**PLANNING COMMISSION MEETING**  
**LOCATION: TOWNSHIP ANNEX, 7527 HIGHLAND ROAD, WHITE LAKE, MI 48383**  
**THURSDAY, JUNE 04, 2026 – 6:30 PM**

Project Name: Mack Industries  
 Description: Preliminary and final site plan approval  
 Date on Agenda this packet pertains to: June 4<sup>th</sup>, 2026

**RE: Mack Industries Addition - Preliminary Site Plan Review- 2<sup>nd</sup> Review  
-Final Site Plan Review-1<sup>st</sup> Review**

REVISIONS	DATE	BY	REASON
4-30-2026			REVISED PER OWNER
4-1-2026			BUILDING PERMIT
3-30-2026			SITE PLAN APPROVAL
			ISSUED FOR
DO NOT SCALE THIS PRINT, USE DIMENSIONS SHOWN ONLY			
DRAWN BY: KY		APPROVED BY: KY	
PROJECT: 2606		SHEET: <b>A3</b>

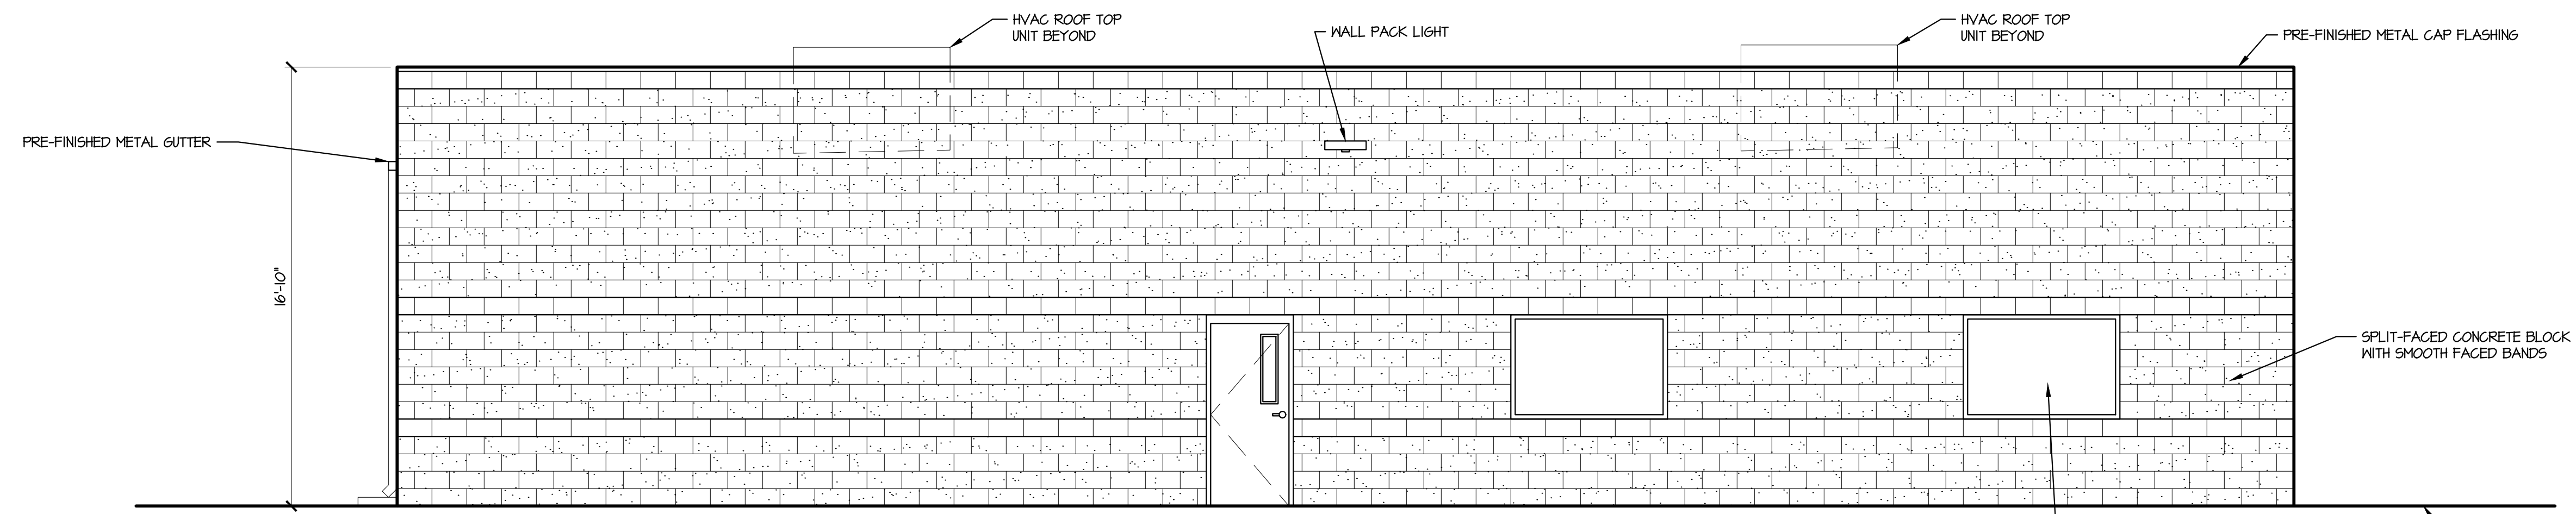
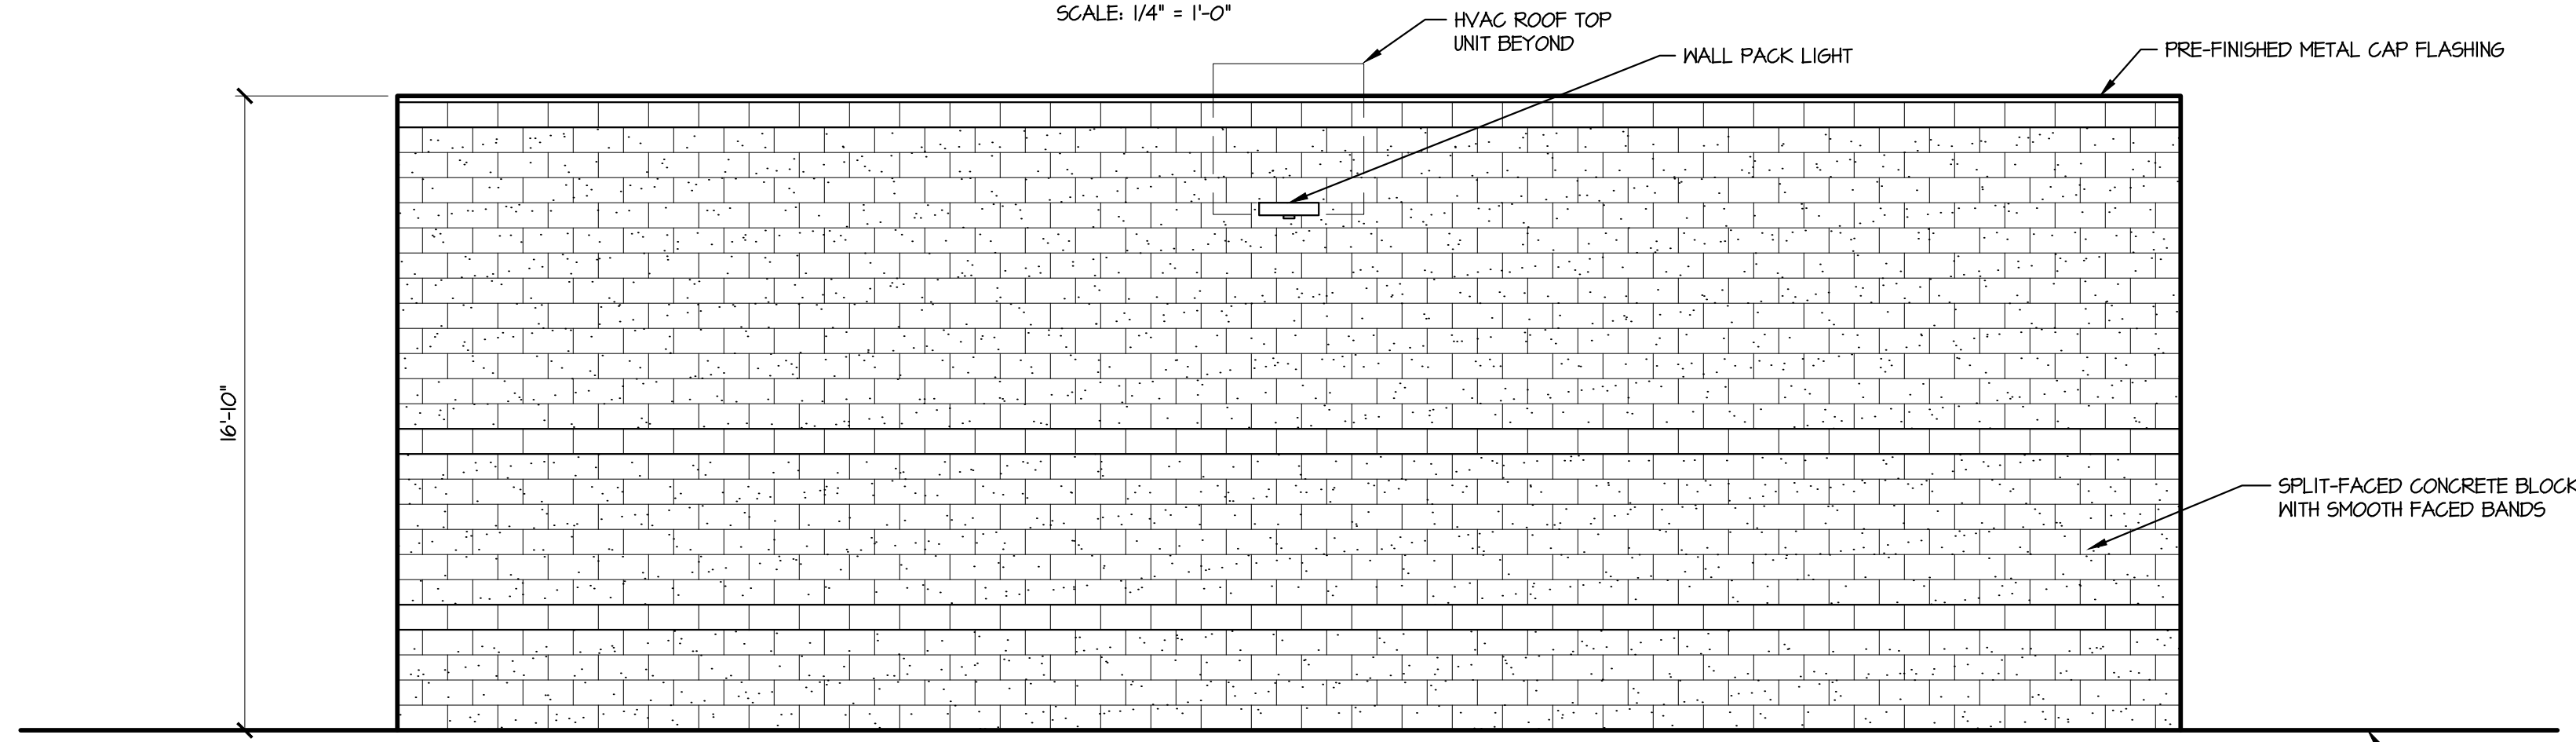
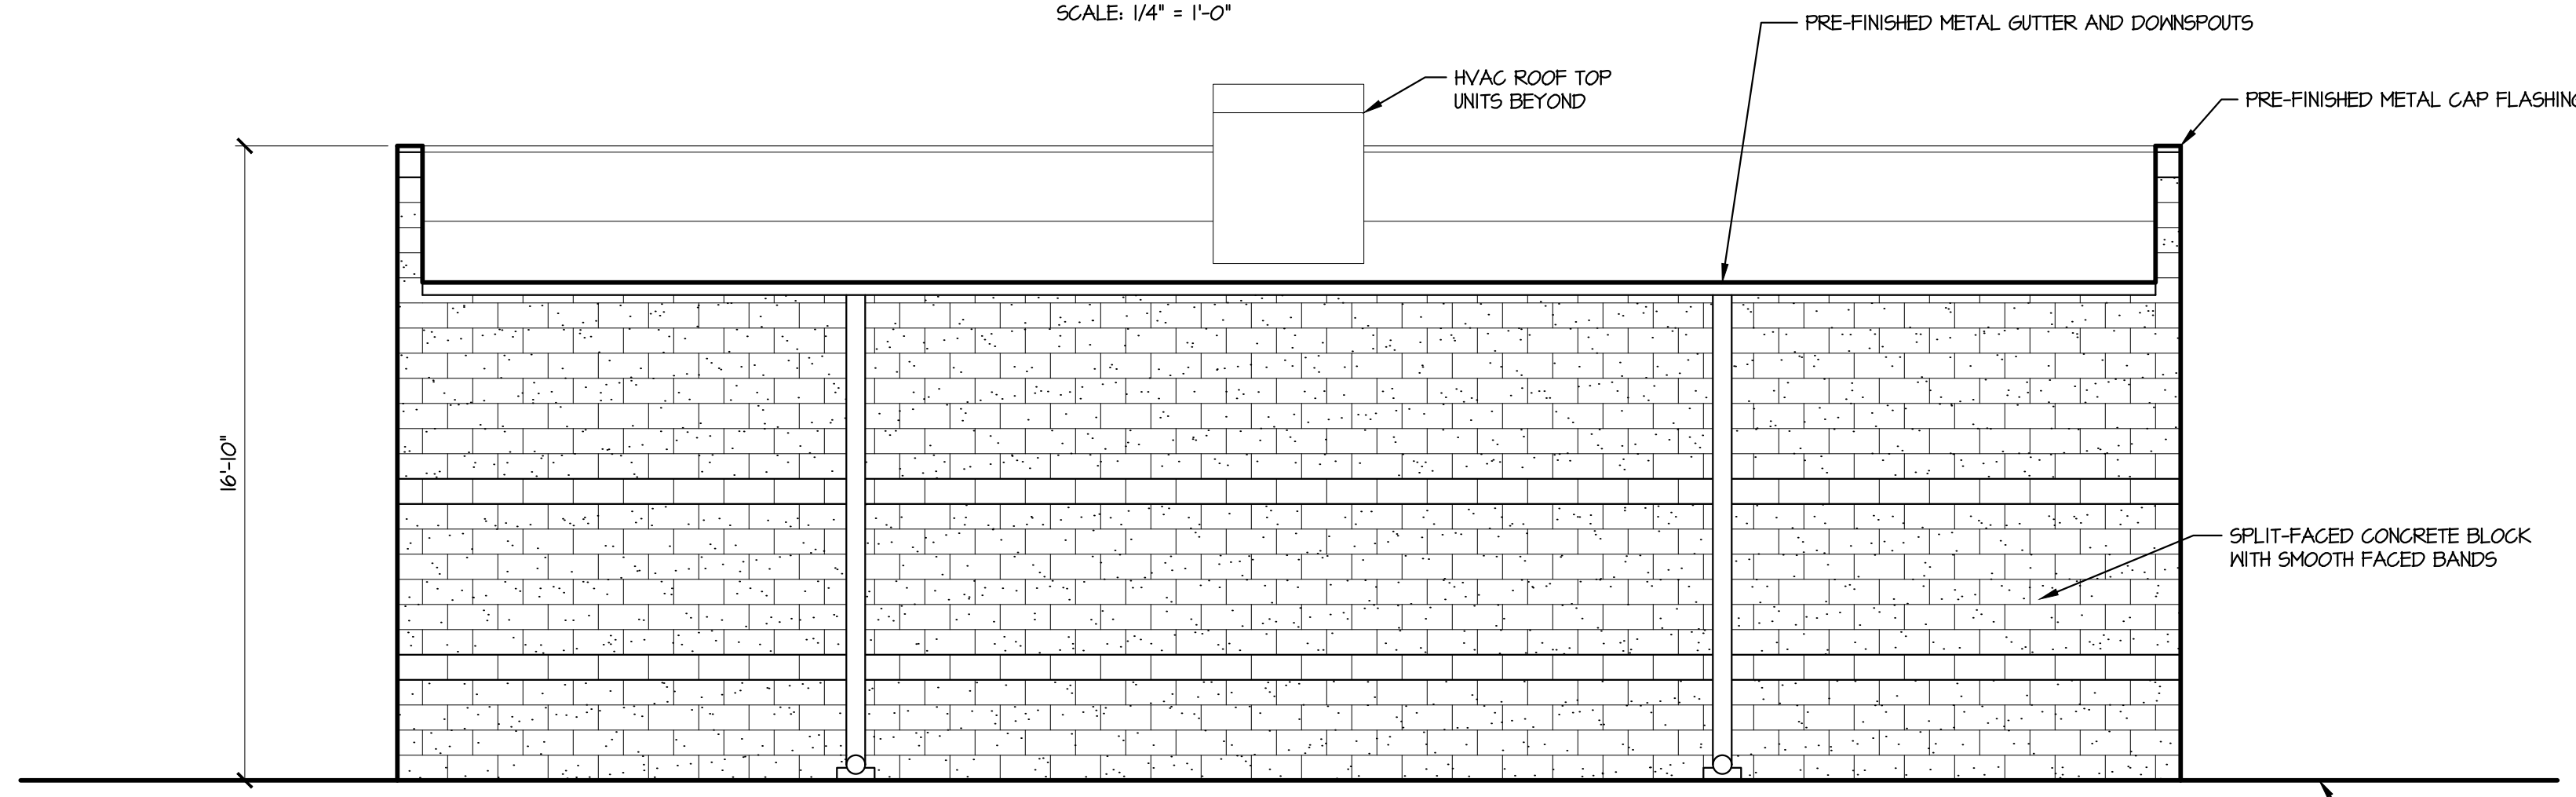
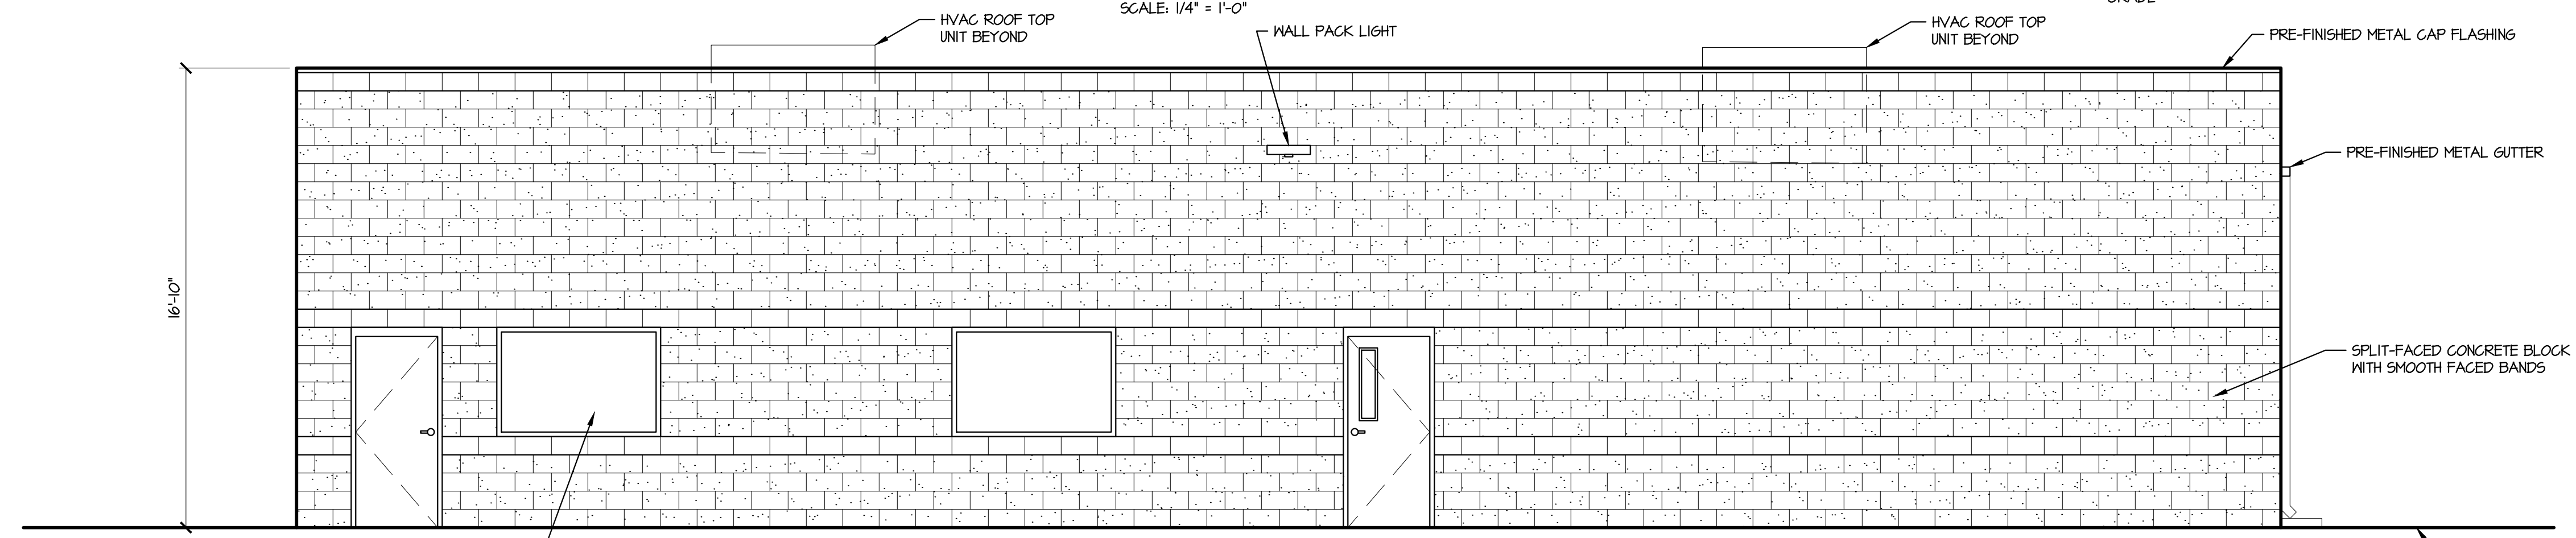
All ground and rooftop equipment will need to be screened per Section 5.19. The applicant states the only rooftop equipment proposed are for the new 3,440 training building and will be screened on three sides as shown on Sheet A4.
